Access Compliance Report

Public Rights-of-Way

Intersection ID: 45516	Main Street: MEADOW_BOTTOM_RD	Cross Street: TRIPLE_OAK_RD	Location: S
ADA ID: 57887123F2B5	Ramp Type: PerpDiag	Initial Pass/Fail: Fail	Overall Compliance: No
Severity Score: 30			
Codes/Mitigation Info/Possible Solution		Field Measurements/Component Compliance

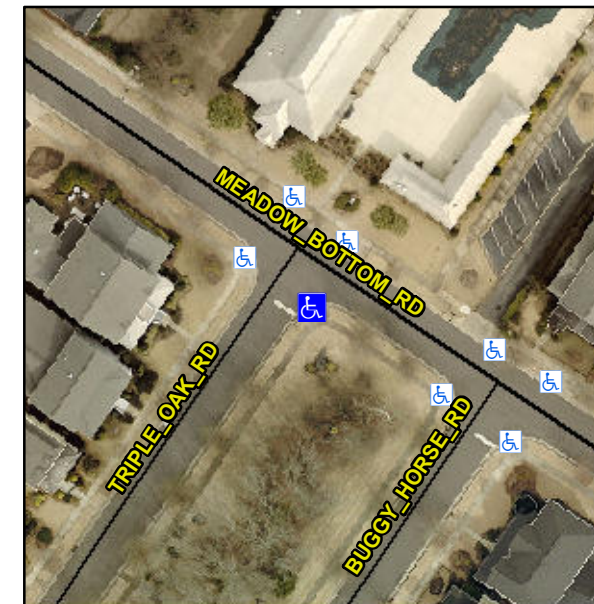
Not Found, R304.5.1, R304.2.2

Compliance	Description	Data	Compliance	Description	Data
N/A	Ramp Length (in)	71.0	No	Ramp Slope (%)	10.9
No	Ramp Width (in)	33.0	Yes	Ramp XSlope (%)	0.9
N/A	Flare Type LT	N/A	N/A	Flare Type RT	N/A
N/A	Flare Slope LT (%)	N/A	N/A	Flare Slope RT (%)	N/A
N/A	Flare Traversable LT?	N/A	N/A	Flare Traversable RT?	N/A
N/A	Landing Length (in)	N/A	N/A	DWS Provided?	N/A
N/A	Landing Width (in)	N/A	N/A	DWS Contrast?	N/A
N/A	Landing Slope (%)	N/A	N/A	DWS Length (in)	N/A
N/A	Landing X Slope (%)	N/A	N/A	DWS Full Width?	N/A
N/A	Landing Curb? (Y/N)	N/A	N/A	DWS Offset (in)	N/A
N/A	Shared Landing?	N/A			
N/A	Gutter Ponding?	N/A	N/A	Gutter Slope (%)	N/A
N/A	Gutter Lip Ht (in)	N/A	N/A	Gutter X Slope (%)	N/A
N/A	Painted X Walk1?	No	N/A	Painted X Walk2?	No
	X Walk 1 Direction	To NE		X Walk 2 Direction	To NW
N/A	X Walk 1 Width (in)	N/A	N/A	X Walk 2 Width (in)	N/A
	X Walk 1 Slope (%)	3.4		X Walk 2 Slope (%)	3.7
	X Walk 1 X Slope (%)	3.6		X Walk 2 X Slope (%)	0.2

Remove & Replace Curb Ramp With Two New Directional Ramps or Equivalent.
